Tivoli Manufacturing Ltd. Extreme (ReMix II) seat side rails

Safety Bulletin

Bulletin No: RMSA007

Purpose: Inspection and Reinforcement of Seat Side Rails

Figure 2

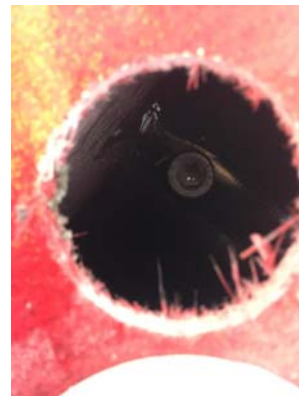
- Cut two 1 ¼" (30mm) access holes with hole saw on bottom of fiberglass seat as indicated on attached picture (see figure 1). These holes are 1 ¾" (45mm) off each side of the centerline on the seat bottom, in line with the center of the side bars.
- Drill and tap two holes (See figure 2 & 3) for an 8mm 1.25 x 25mm (grade 8.8) socket head bolt with washer.
- Install bolts with Loc tite (blue) and tighten snugly
